HCW/13/50 North Devon Highways and Traffic Orders Committee 29 October 2013

Objections received to the advertising of mandatory disabled bays in this HATOC area

Report of the Head of Highways, Capital Development and Waste

Kingsley Avenue - drawing number ENV3463.16

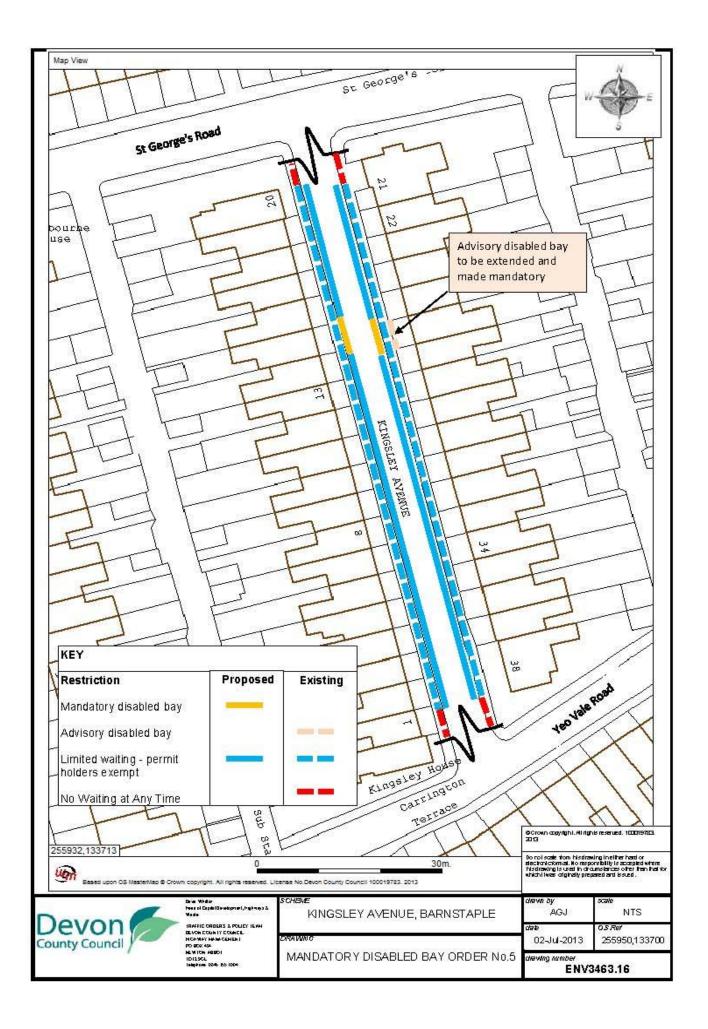
pjections or comments	DCC response
		be made mandatory has highlighted a second bay in the
	eet opposite. Both processed together.	
Fir	st correspondent [letter 7] – Kingsley Avenue.

•	Nothing has altered from when the bay was first marked. Disabled driver has the same vehicle, on street parking is unchanged, standard of parking neither improved nor deteriorated, number of cars at correspondents house has decreased by 50%.	 View noted - appears to refer to the original bay marked in this street.in the light of the proximity of these two bays they need to be processed together. Views noted.

•	New bay made directly opposite – less than 6 feet between.	• This is why they are being progressed together.
•	New bay is far too big – whereas vehicle just fits inside other bay – solution would be to swap bays. None are that severely disabled that they would be unable to use the bay.	 A disabled bay must now be marked to a minimum length of 6.6 metres in order that it be suitable for any blue badge holder including manoeuvring and wheelchair access to the boot. The new bay has been marked at that size and the advertising of both bays is to that size. The older bay will be increased in length to suit the new order.

•	This would save money, time and effort while not affecting anybody other than the two badge holders.	View noted.
res	bey Road – request for new mandatory disabled bay - sidents' parking and single yellow line opposite. cond correspondent [letter 8] – Abbey Road – two	- single yellow line on side of road where applicant lives -
	st letter

It is recommended that these bays be made and sealed as advertised.

Abbey Road – drawing numberENV3463.24

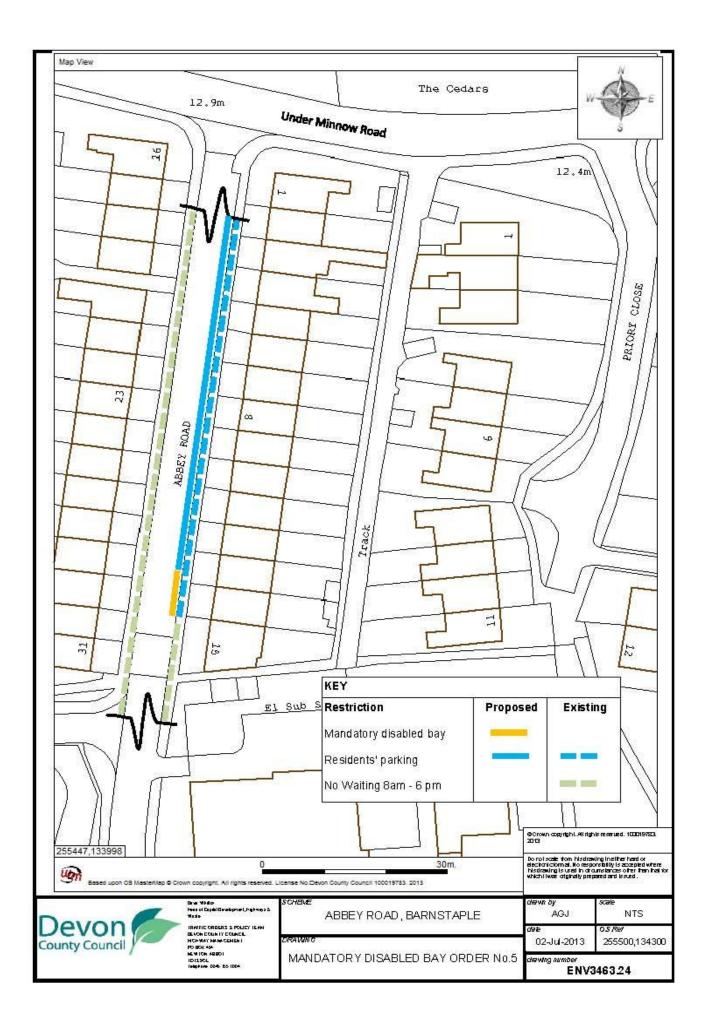
•	Objects to bay being marked immediately outside their house.	Noted.
•	The applicant, who lives opposite, already have a parking space behind their house as have all the houses opposite. Applicant has let it be known they intend to move house "in the very near future".	 It is understood that the applicant has grassed over the parking place they used to have off the rear service lane. The applicant has been contacted and confirms that they intend to move but suggests that next summer is a more likely date.

•	Main objection is that the bay would severely affect the value of their home compared to the rest of the road. Advice from two local estate agents confirms this view.	 Views noted – however the right to park outside or even near to one's home does not exist.

•	Will be taking legal advice as it has been suggested they may be entitled to compensation.	 Noted – it is not considered that compensation would be appropriate.
Se	cond letter

•	Does not agree that applicant has experienced	 View noted – Abbey Road has been a part of a residents' parking scheme for a number of years

Objections or comments	DCC response
 Applicant has access to a parking space behind his house which he has previously used. He has chosen to grass over this area since his application – this could easily be reversed. All the houses on that side of the road have parking spaces behind their property and are therefore worth up to £20,000 more than the other side of the road. Their parking space should be on their tenancy 	 Comment noted – applicant has been contacted and states that he made his application for a bay after receipt of a new, larger mobility vehicle in which he had difficulty accessing the rear lane and scratched the vehicle on the first attempt. View noted.
 agreement. In the eight years they have lived there the applicant has been able to park outside the house next door, which has a drive and garage, on a single yellow line using his blue badge. He has done this without obstructing anybody or anyone raising objection. Would it not be possible for the bay to be put here as no fines have ever been issued? 	 the County Council. The space referred to is on a length of single yellow line to the north of the driveway. This length of line would have been provided, probably with the residents' parking scheme, to allow visibility for egress from the drive to this house; it is significantly more extensive than would normally be provided for a single driveway. It is not long enough to mark a bay to the required 6.6 metres. A disabled bay must be marked at least 6.6 metres long to comply with the Traffic Signs Regulations and General Directions which allows for manoeuvring space and access to the boot for wheelchair users. It has been recorded that the owner of this house would not be averse to a reduction in the length of the single yellow line to permit this parking bay but the officer who attended the site to survey it and produce the schedules and plan considered this inappropriate. A subsequent site inspection agrees the correspondents' views that the length of the single yellow line could be reduced. However, in view of the required dimensions of a bay it is not considered feasible to mark a bay wholly on the single yellow line but that half the bay could be accommodated on the single yellow line and half on the residents' parking bay. This would leave visibility from the drive appropriate to the circumstances. This would need further advertising – see recommendation below.

• There is an acute parking problem already in this road – taking away, effectively, two parking spaces will make matters significantly worse.	 View noted – the bay is advertised at 6.6 metres long – about 1.5 spaces.

• Concerned that a disabled bay directly outside their house will effectively devalue their property. Advice from two local estate agents confirms this view – will put off prospective buyers as they will never be able to park outside so will expect to pay less compared to every other house in the road.	 Views noted and understood – however the right to park outside or even near to one's home does not exist.
 Will make loading and unloading incredibly difficult. 	• Comment noted – it is considered that should this be a problem at any time normal neighbourly behaviour should prevail.
 If proposal goes ahead they will be taking legal advice. Is aware that applicant has said his car is too big to access the rear parking citing one occasion he had scratched it. Also knows that a builder parks his much larger van there frequently. 	 Noted – it is not considered that compensation would be appropriate. See above with respect to applicant's vehicle.

• Applicant parks successfully in the space below the proposed bay and has done for many years. This is in front of a property which has its own drive and garage and as such not adversely affected. This is where the applicant wanted his space.	• Assume correspondent means that applicant parks on the single yellow line between the end of the residents' parking bay and the private driveway. See above for use of this area and below for recommendation.

• If space provided as advertised will undoubtedly affect the value of the properties it is outside.	Comment noted – see second correspondent above.
Aware that residents are not entitled to a particular	• Noted.

It is recommended that this bay not be progressed but that further advertising take place as described in the appendix.

Yeo Vale Road - drawing numberENV3463.26

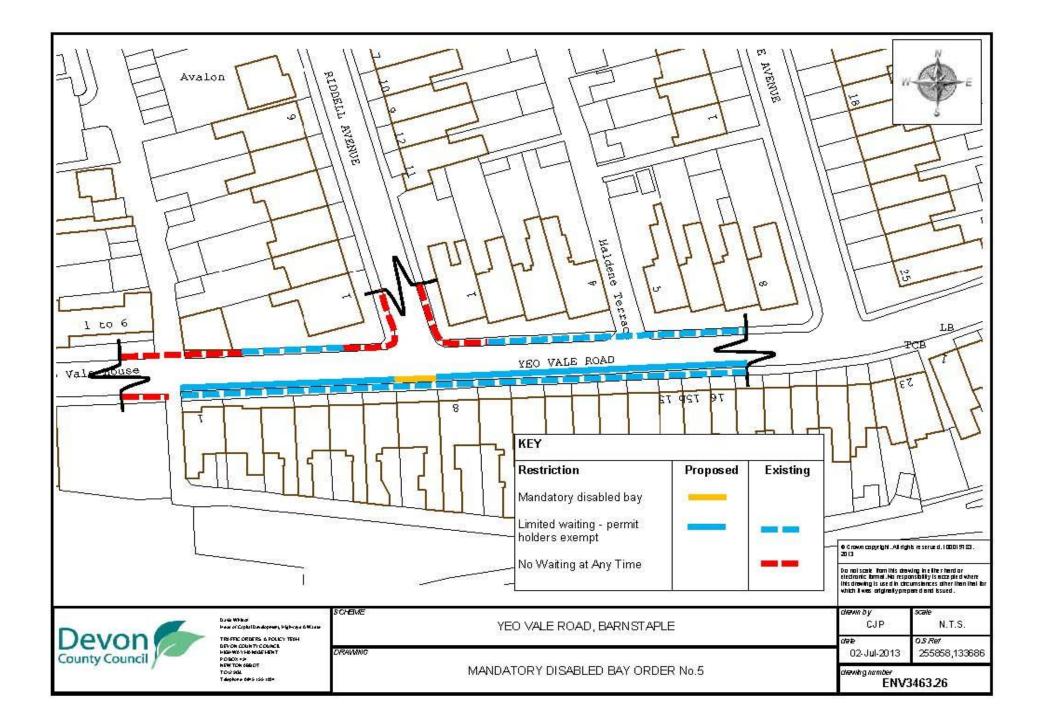
schools in Abbey Road with a serious lack of Civil	
Enforcement Officer present. To further erode	
these spaces in this way would seem impractical	
when a suitable space could be created exactly	
where the applicant successfully parks now – a	
space that no one else can use.	not be marked as advartised and at the first encerturity
Recommended that: in view of the responses the bay further advertising be undertaken to place the bay half [3]	
residents' parking bay. This advertising would take plac	
progressed shortly.	e with the next batch of disabled parking bays to be
Yeo Vale Road – request for a new mandatory disabled	bay within an existing shared use residents' parking/limited
waiting parking bay.	, , , , , , , , , , , , , , , , , , , ,
Seventh correspondent [letter 15] – Yeo Vale Road.	
Makes the correct assessment with respect to who	It has been confirmed that the original applicant has
the applicant was and states that he has recently	died so the bay is no longer required.

died. If he was to be the main user the	
requirement has gone.	
Correspondent and her husband are dependent	
on daughter [an essential visitor who visits daily]	
and a team of support carers who attend up to	
three times a day. These supporting visitors are	
required to park as paar as possible due to loading	
required to park as near as possible due to loading and time constraints	
and time constraints.	
and time constraints.If this proposal goes ahead asks that it does not	
 and time constraints. If this proposal goes ahead asks that it does not encroach in front of their house. 	ff Yeo Vale Road]
and time constraints.If this proposal goes ahead asks that it does not	
 and time constraints. If this proposal goes ahead asks that it does not encroach in front of their house. Eighth correspondent [letter 17] – Carlyle Avenue [or content is a second secon	
 and time constraints. If this proposal goes ahead asks that it does not encroach in front of their house. Eighth correspondent [letter 17] – Carlyle Avenue [o There is already very limited space for parking in 	Correspondent has misunderstood the reason for

It is recommended that this bay not be progressed.
